**Town of Duanesburg
Zoning Board of Appeals
July 19th, 2022**

Town of Duanesburg
Zoning Board Minutes
June 21st, 2022
Draft Copy

**TOWN OF DUANESBURG ZONING BOARD OF APPEALS
RESOLUTION ISSUING INTERPRETATION OR IN THE ALTERNATIVE
APPROVING AN AREA VARIANCE TO ALLOW EIGHT FEET TALL FENCES
AT THE OAK HILL SOLAR PROJECTS**

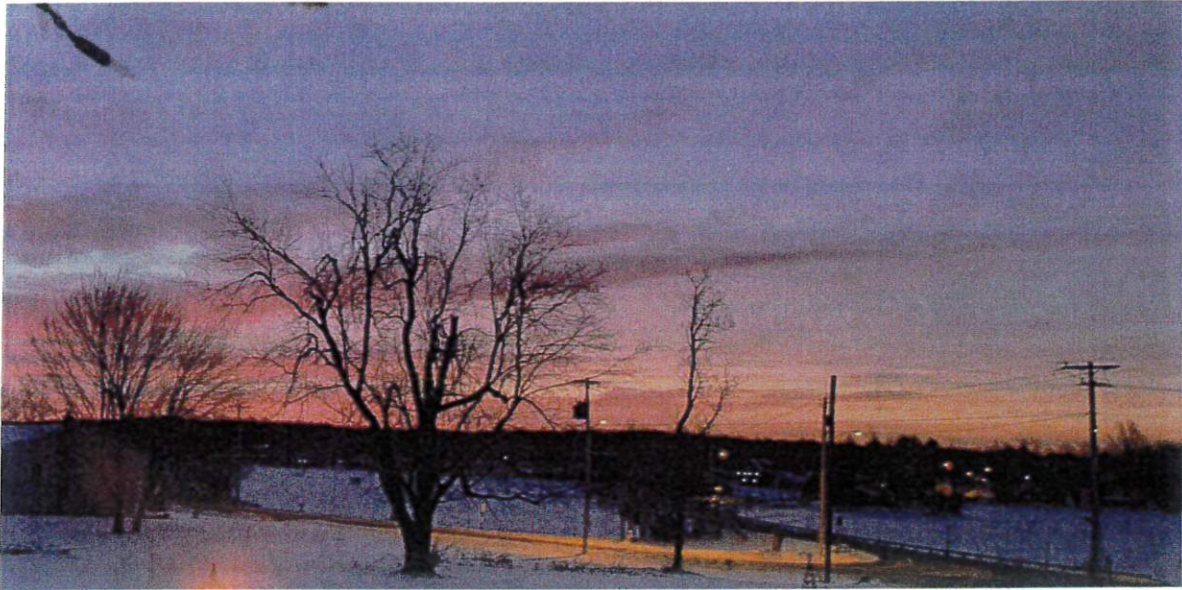
Position of the house to the West of 2610. Note the angle of the house which was done for the views of the lake.

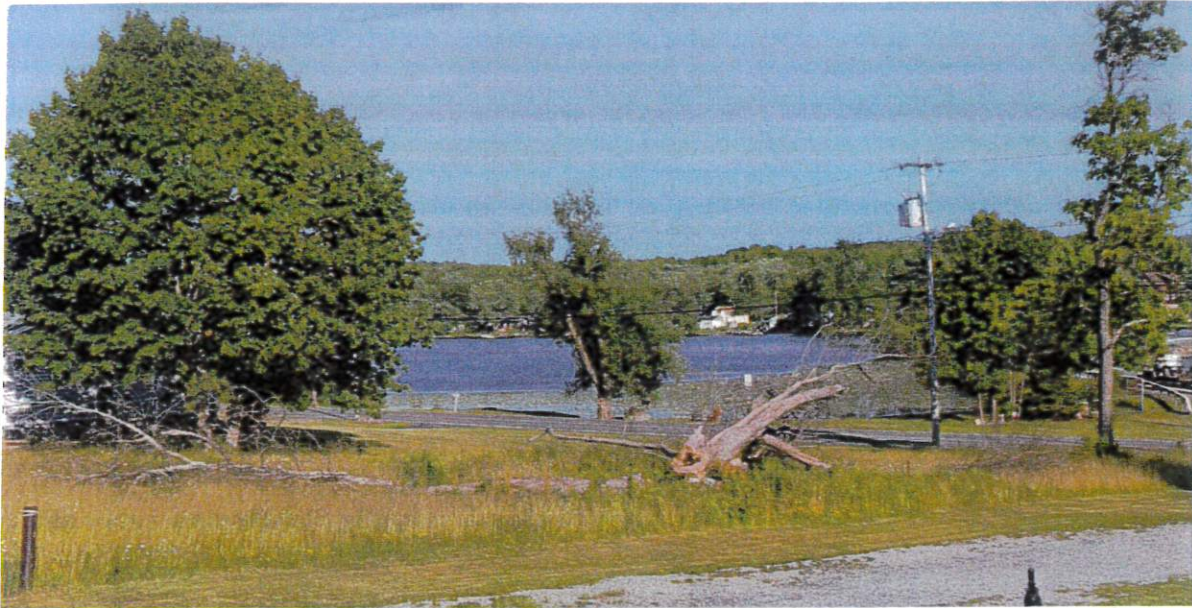
View from the west side. Note that both sides of the lake are in view.

Current view. Placing on home in this area will completely block the view.

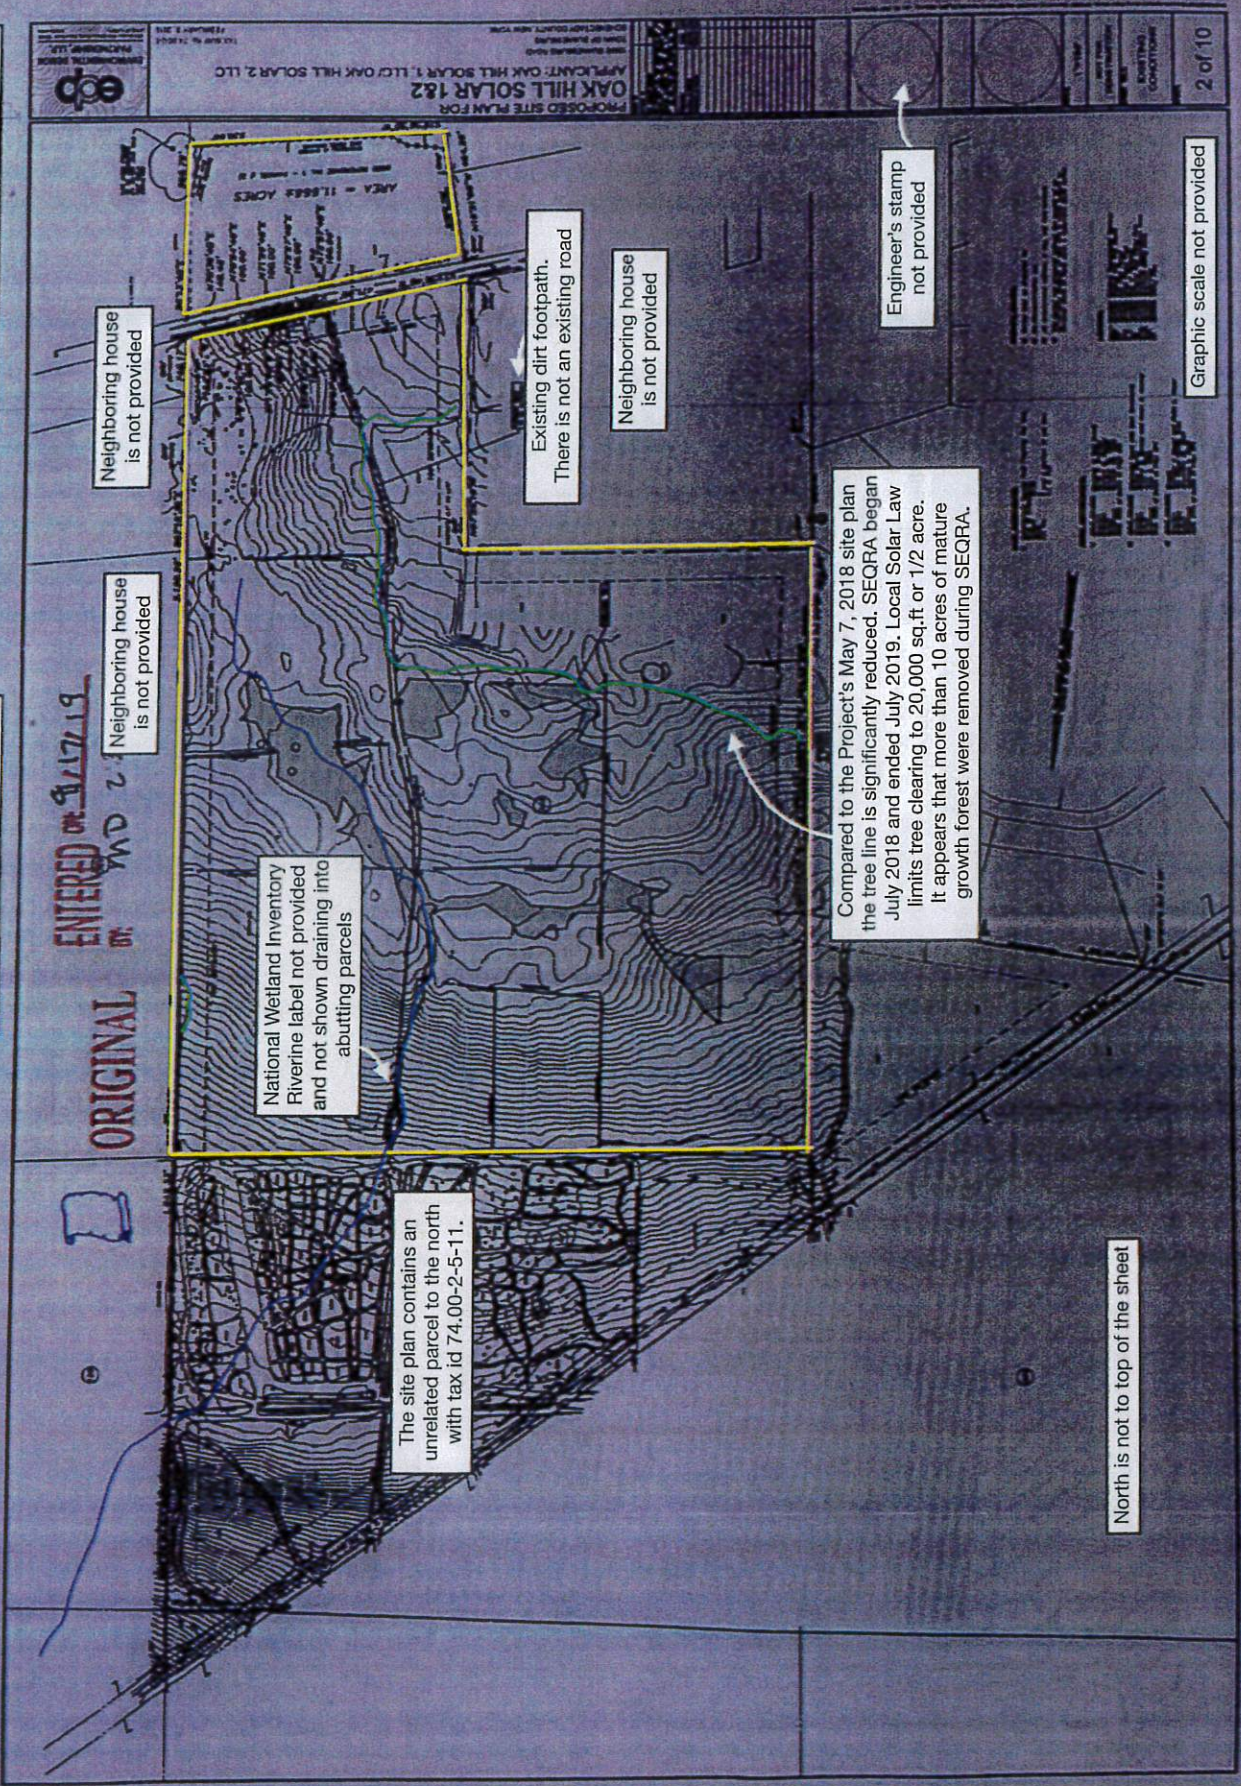
Sheet 1 of 10: A scale is not provided, graphic scale is not provided, includes unrelated tax id parcel to the north, abutter's houses are not provided, locations of 200+ tracking motors are not provided, engineer stamp is not provided.

Image is not centered on the page

The site plan contains an unrelated parcel to the north with tax id 74.00-2-5-11.

North is not to top of the sheet

Graphic scale not provided

Exhibit B Biggs/Bruning to Zoning Board June 20, 2022

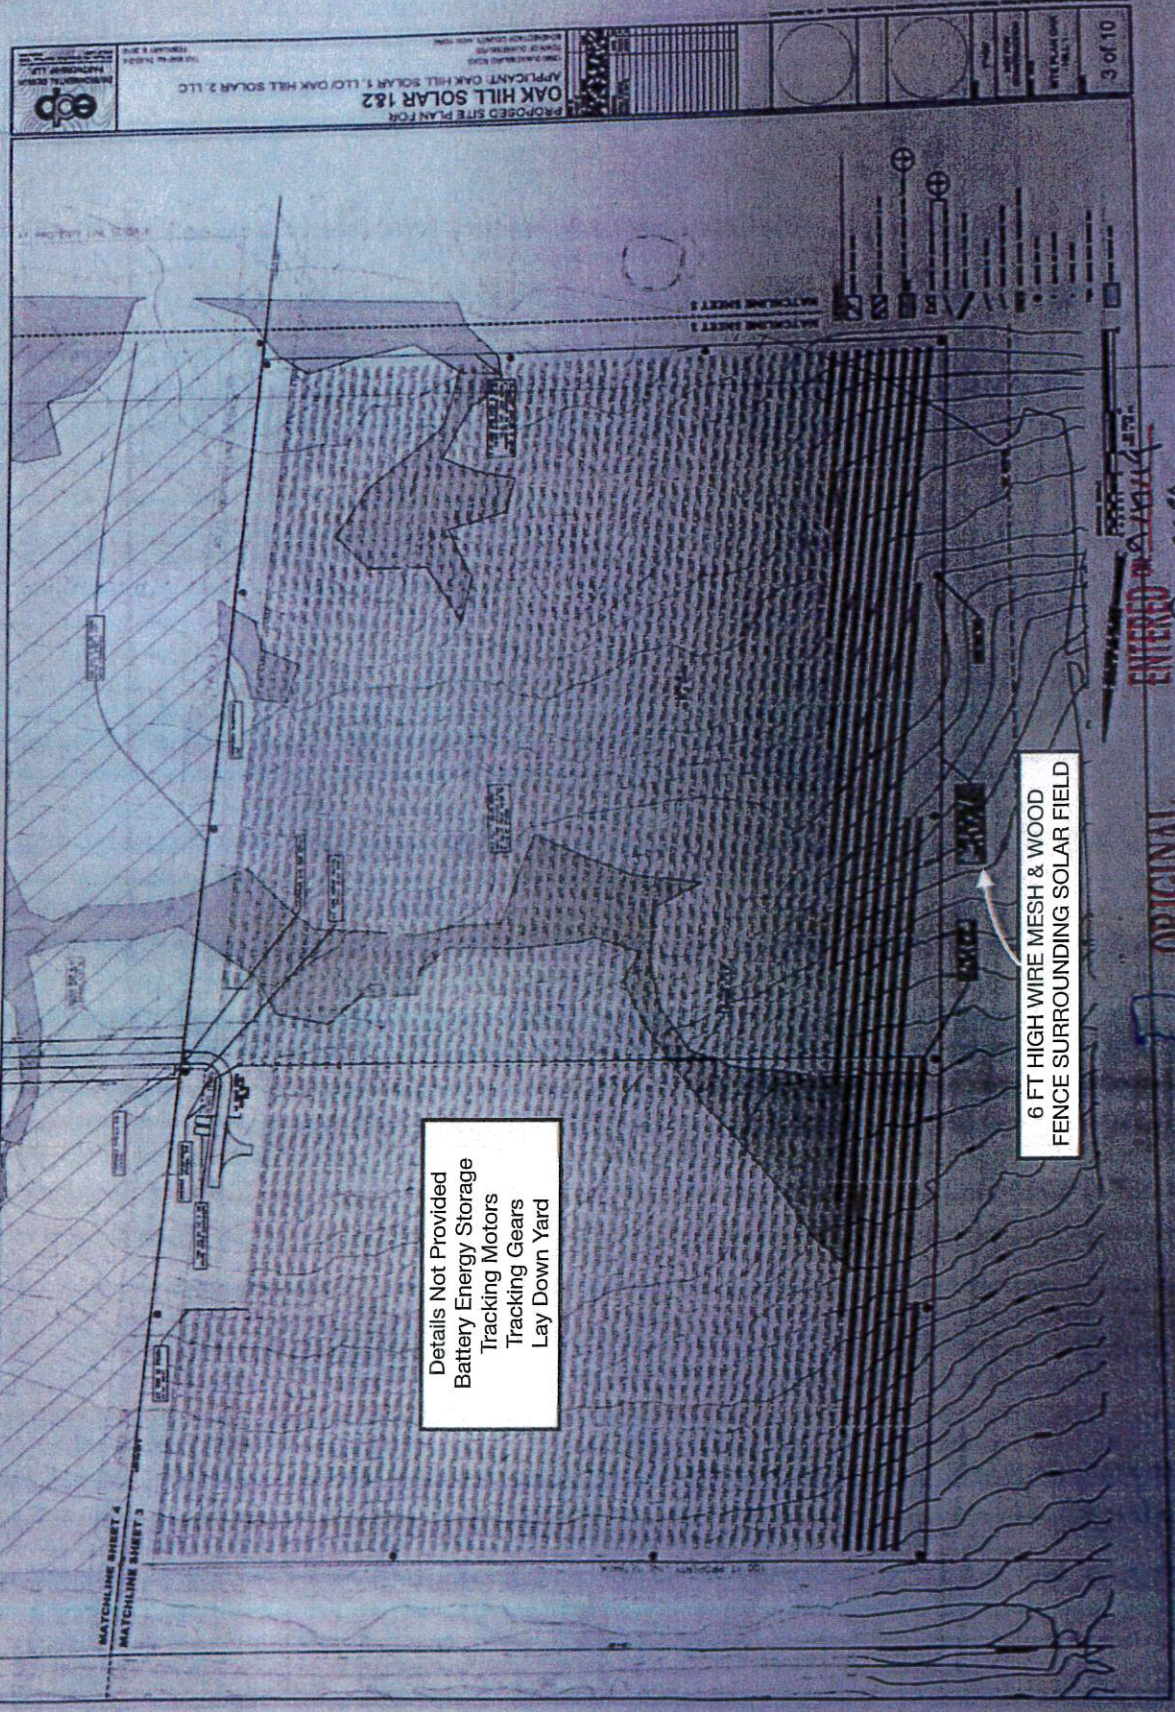
Sheet 2 of 10: The tree line is significantly reduced compared to the May 7, 2018 site plan. The State Environmental Quality Review Act (the "SEQRA") began July 2018 and ended July 2019. Comparison of the May 7, 2018 site plan and the approved site plan dated June 6, 2019 Sheets 1 through 10 of 10 indicates that more than 10 acres of mature growth forest was removed. Duanesburg Solar Law limits tree clearing to 20,000 square feet, or less than 1/2 acre. Furthermore, it is a violation of SEQRA 617.3(a) to alter a project site while SEQRA is in effect. A graphic scale not provided, abutter's houses are not provided, location of the lay down yards, and a label for National Wetland Inventory are not provided.

Compared to the Project's May 7, 2018 site plan the tree line is significantly reduced. SEQRA began July 2018 and ended July 2019. Local Solar Law limits tree clearing to 20,000 sq.ft or 1/2 acre. It appears that more than 10 acres of mature growth forest were removed during SEQRA.

Details Not Provided
 Battery Energy Storage
 Tracking Motors
 Tracking Gears
 Lay Down Yard

Exhibit B Biggs/Bruning to Zoning Board June 20, 2022

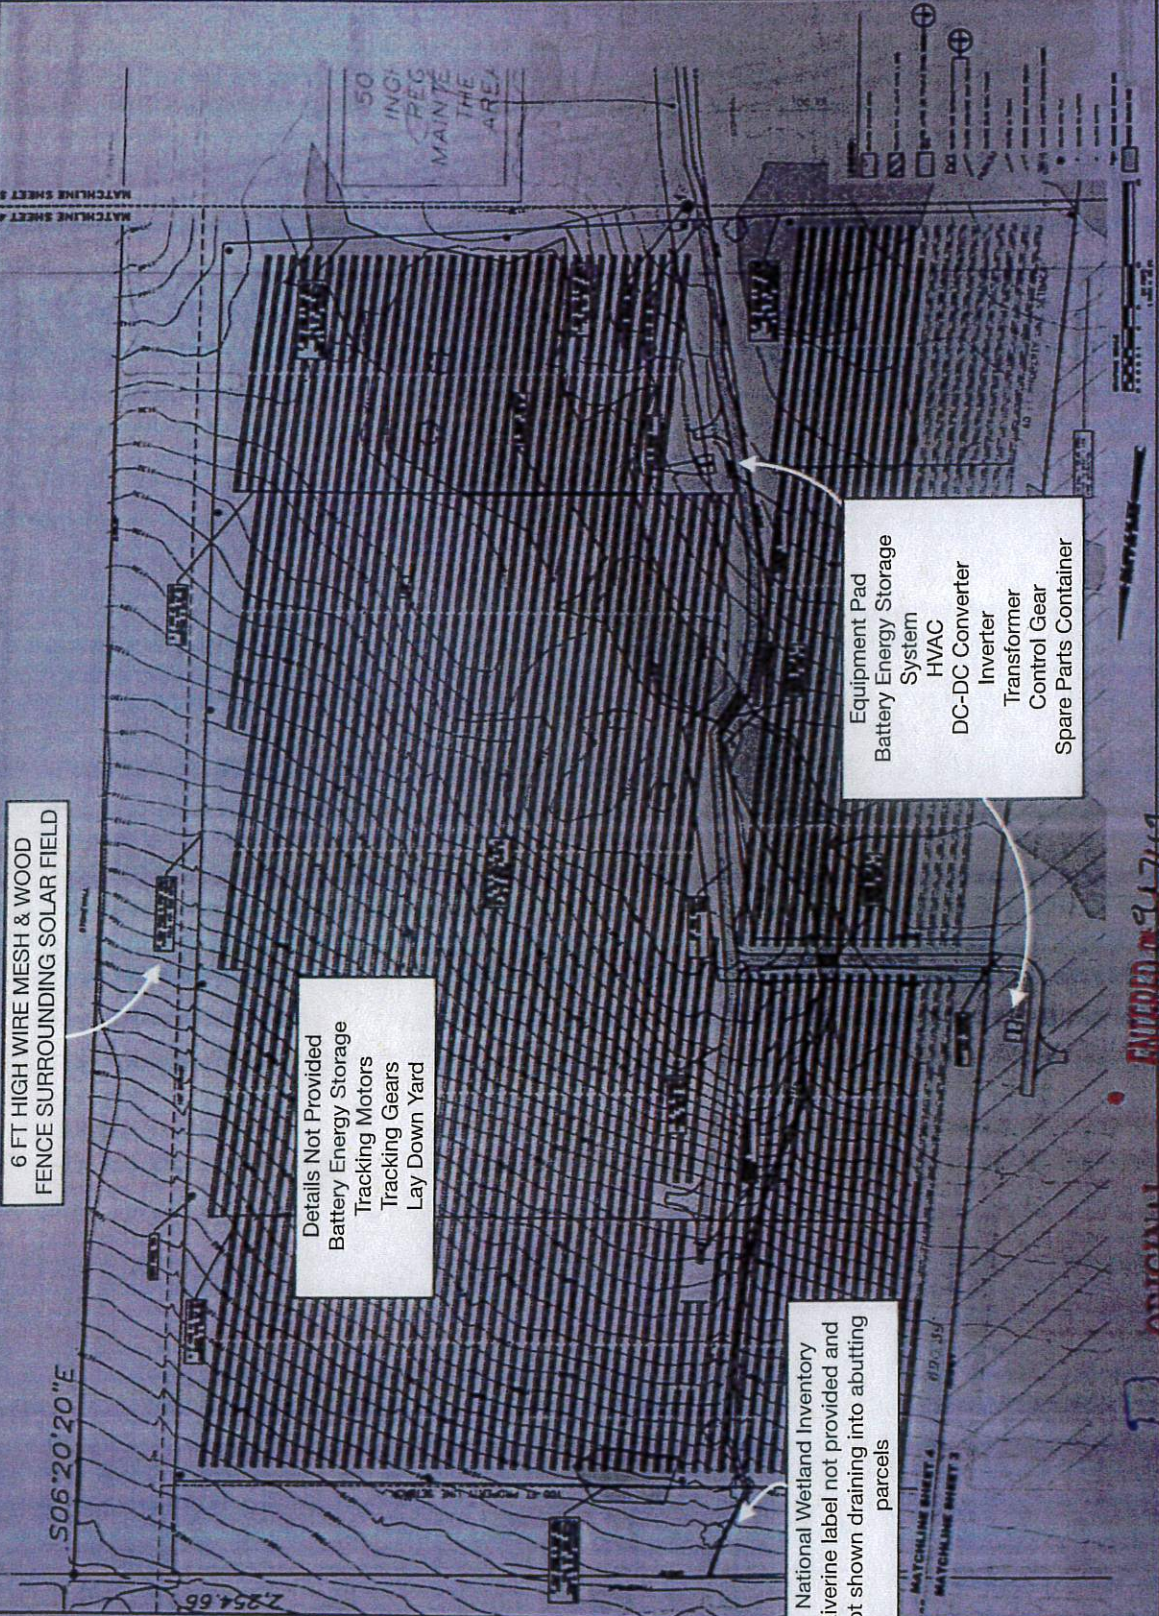
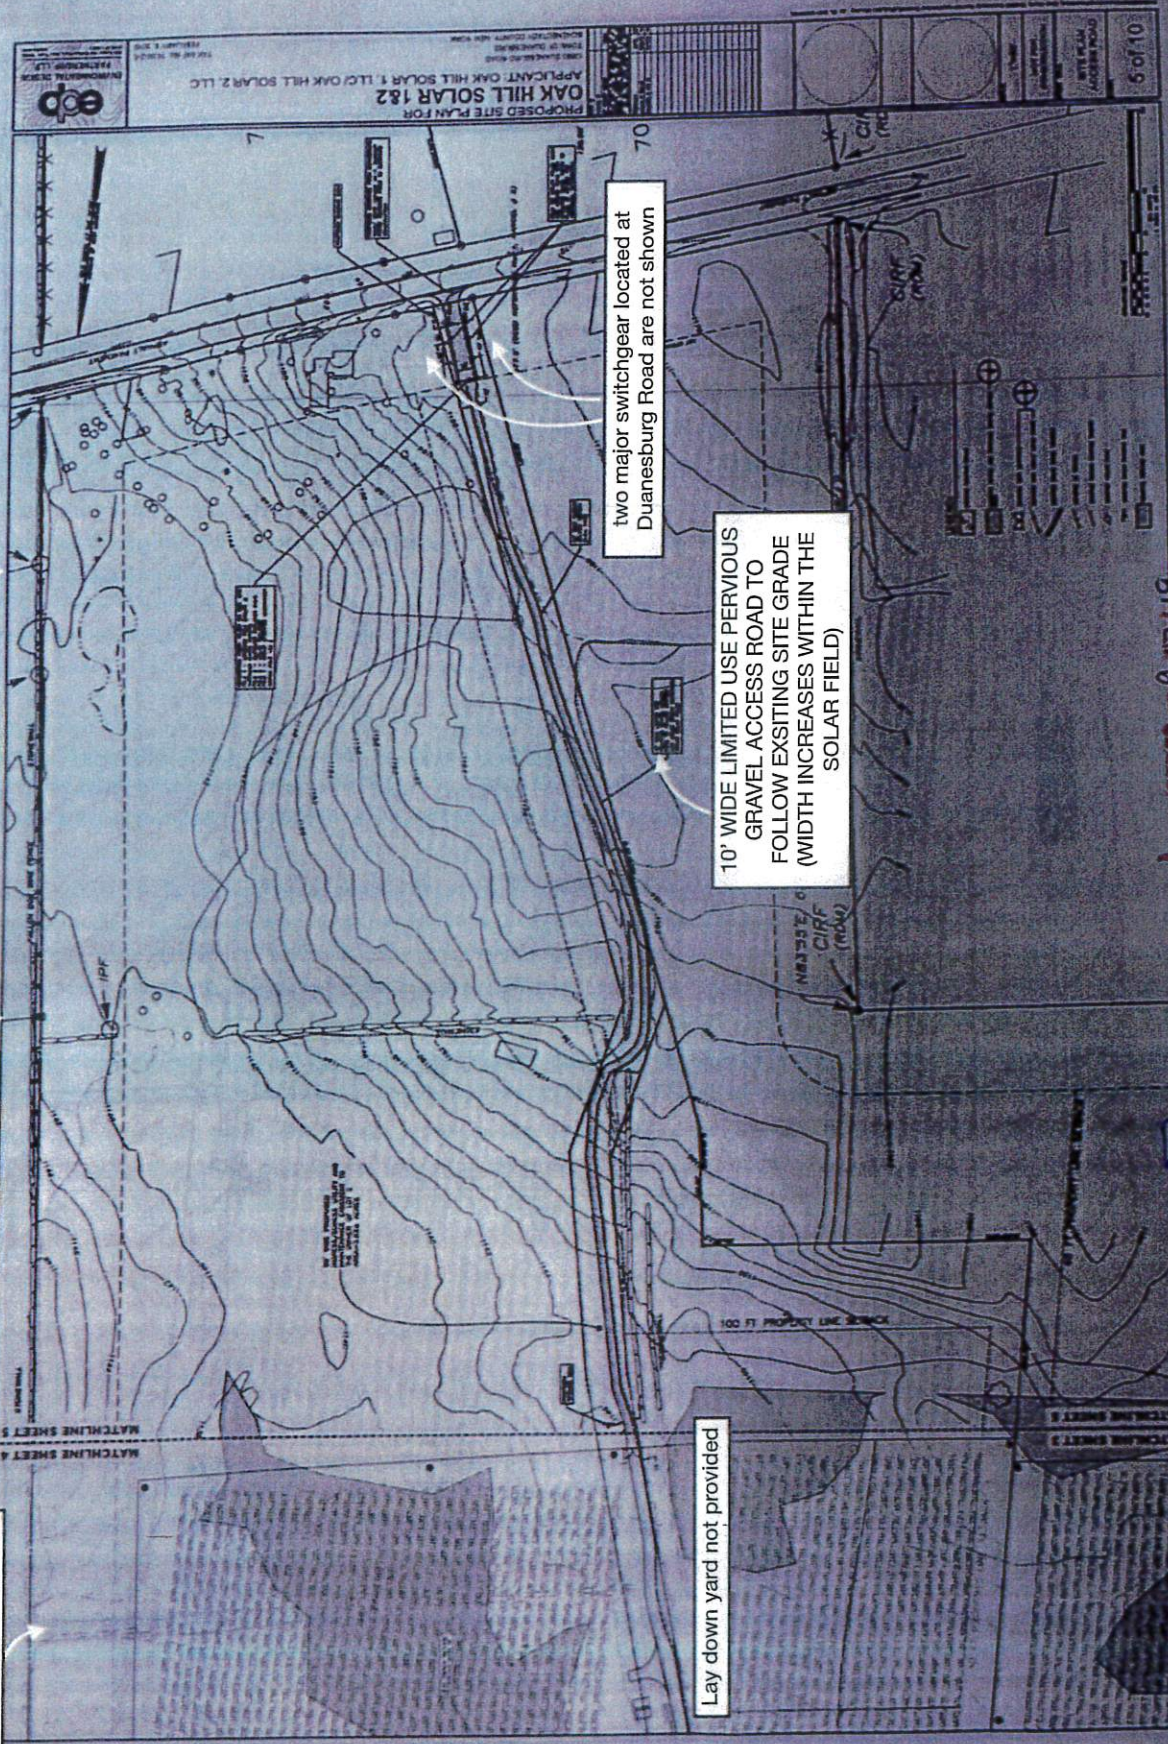
Sheet 3 and 4 of 10: The battery storage locations, tracking motors, tracking gears and lay down yards are not provided. A full equipment list and location for battery energy storage, HVAC, tracking motors, tracking gears, DC-DC converters, and control gear are not provided.

6 FT HIGH WIRE MESH & WOOD FENCE SURROUNDING SOLAR FIELD

Lay down yard not provided
